Stage 03: Report to the Authority

GC0076 Grid Code Limits On Rapid Voltage Changes

03 Report to the Authority

The purpose of this document is to assist the Authority in its decision of whether to implement the proposed Grid Code Modification.

Figure CC.6.1.7 -
Time and magnitude limits for a category 3 Rapid Voltage Change

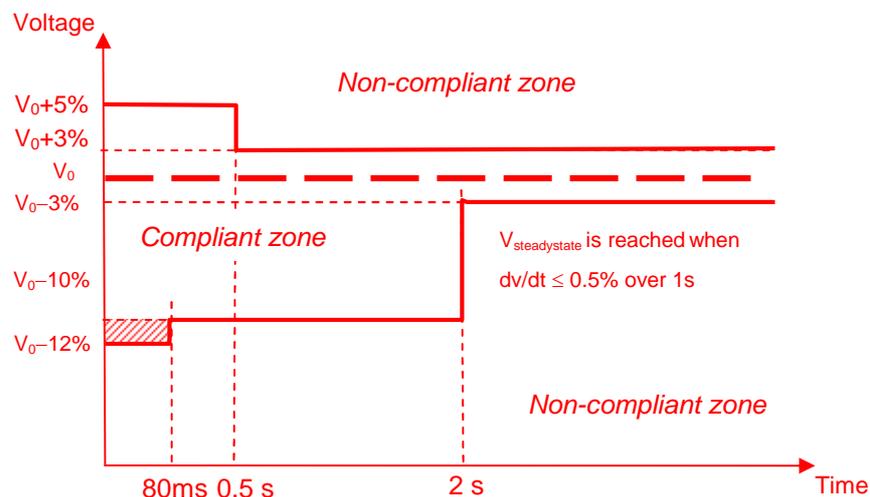
<p><i>In proposed Figure CC6.1.7:</i></p> <ul style="list-style-type: none"> <i>• the reason for a proposed $V_0+5\%$ for 0.5s compliant zone is not discussed in the consultation document. What is National Grid’s reasoning for this?</i> <i>• the relevance of the statement “$V_{steadystate}$ when $dv/dt \leq 0.5\%$ over 1s” to the diagram is not clear.</i> <i>• The relationship of the unnamed vertical axis with $\% \Delta V_{steadystate}$ and $\% \Delta V_{max}$ is not clear</i> <i>• I assume that the unnamed horizontal axis represents time between voltage disturbances</i>

<ul style="list-style-type: none">• <i>The time parameters which were proposed in consultation document figure 2 have been omitted from Figure CC6.1.7</i>• <i>Table CC.6.1.7 category 3 says $\% \Delta V_{max}$ up to 12% may be acceptable but Figure CC6.1.7 only allows negative rapid voltage changes of this magnitude (while allowing positive and negative rapid voltage changes of 3%). What is the reason for this?</i>
--	--

<p>Please provide any other comments you feel are relevant to the proposed change.</p>	<ol style="list-style-type: none"> 1) There is a need to include the note from Section 3.32 (4) of the Consultation document to explain the shaded area ie: The shaded area is proposed as it is in accordance with the 12% voltage change stipulated in NETS SQSS. The duration of the maximum allowable depth (V0 - 12%) has been specified in coordination with fast acting voltage controllers. 2) In the second column of Table CC6.1.7, the word 'No' in rows 2 and 3 should have a capital 'N' 3) In the last paragraph of CC6.1.7 (vii) add the word voltage so that the sentence reads'....the total number of voltage changes at the....'

- 4.11 Suggested changes and improvements to table CC6.1.7 were included in the revised proposals. Table 3 below is the version presented in the first consultation document. Table 4 is the amended version included in the legal text the second consultation. One response had highlighted that times were missing from the x-axis of the Figure CC.6.1.7 which was corrected.

The shaded area of -12% for 80ms in the Proposal GC0076 (Figure CC.6.1.7) is consistent with the $\pm 12\%$ voltage change stipulated in NETS SQSS. The duration of the maximum allowable depth ($V_o - 12\%$) has been specified in coordination with fast acting voltage controllers. The other consideration was coordination with ER G59 requirement for protection of embedded generation to avoid inappropriate trips of generators.

Fig 1: Stage 1 and Stage 2 Protection Requirement in ER G59 for Under-Voltage Protection and GC0076 Requirement for Pre-Event Voltage at Nominal Level

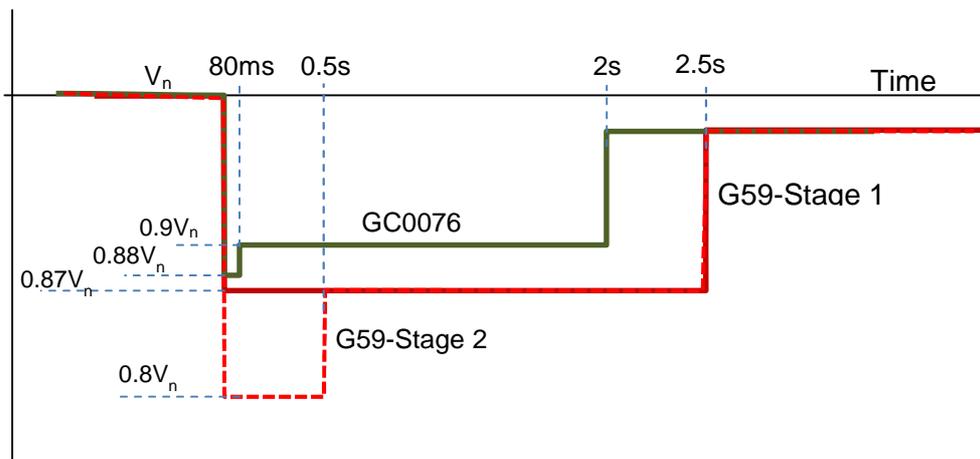
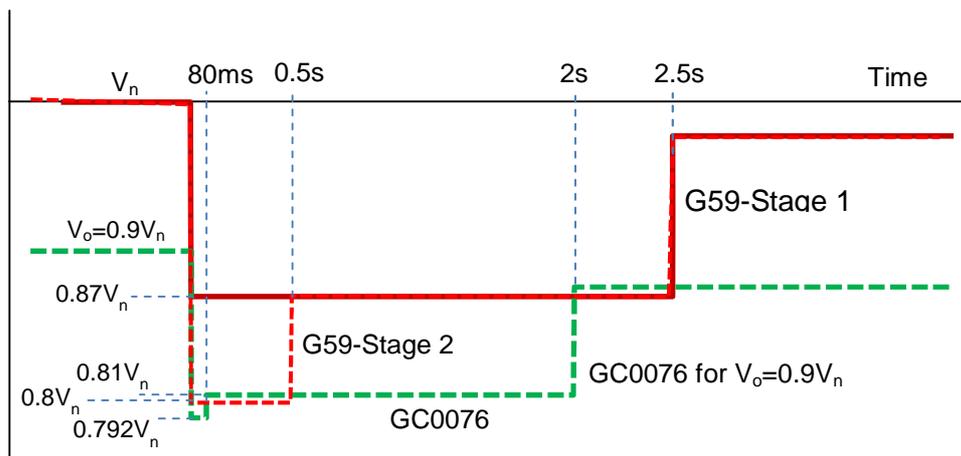
<p><i>change of 12% on the upstream EHV system could reduce the voltage at the customer supply terminals well below the protection setting and hence operate the undervoltage protection. If such an event is infrequent then this could be acceptable. However, the proposal GC0076 would permit such events to be frequent (i.e. 4 per day) during commissioning, maintenance and fault restoration. Note that there are a number of issues that may affect the above in practice; for instance, voltage within a customer installation may be lower than at the supply terminals, typically distribution networks operate with some margin within the permitted range (although there is increasing pressure to shift the range downwards to reduce losses), rapid voltage changes may not be balanced, transformation through transformers etc.</i></p> <p><i>Note also that the proposed change as given in Table 1 Category 3 seems inconsistent with the strict regime given by the SQSS Table 6.2 where 12% voltage changes are only permitted for rare faults (i.e. loss of double circuit overhead line, loss of a section of busbar or mesh corner or loss of a supergrid transformer).</i></p>

Figure 1 shows the ER G59 Stage 1 and Stage 2 requirements. It also illustrates the proposed voltage change criteria in GC0076 when the pre-event voltage is at nominal level.

According to Proposal GC0076 the reference voltage is the pre-event voltage, V_o . For V_o of 90% of nominal voltage V_n then the allowable voltage change is $0.12 \times 0.9V_n = 0.108V_n$, thus the retained voltage would be 79.2% of V_n . For $V_o = 90\%$ of V_n , the voltage must recover to 81% of V_n within 80ms, thus above the ER G59 protection level. Figure 2 shows the ER G59 Stage 1 and Stage 2 requirements and proposed voltage change criteria in GC0076 when the pre-event voltage is at 90% of the nominal. It can be seen that the requirement in GC0076 is still above the ER G59 requirement and thus would not cause trips.

Note that the voltage changes depicted in Fig 1 and Fig 2 have been shown without considering the transfer coefficients from EHV to lower voltages. Therefore the green lines in Fig 1 and Fig 2 should be raised according to the transfer coefficients, providing larger margins between the GC0076 voltage change limits and the ER G59 protection requirements. For example, for a pre-event voltage of 90% of the nominal a maximum allowable voltage change in EHV is 10.8%.

According to the transfer coefficients given in Table 1, the embedded generators at 132kV would sense only $0.85 \times 10.8 = 9.18\%$ voltage change, which is less than the Stage 2 limit in ER G59.

Therefore, it can be demonstrated that the limits proposed in GC0076 do not conflict with the voltage related Loss of Mains protection requirements of ER G59.
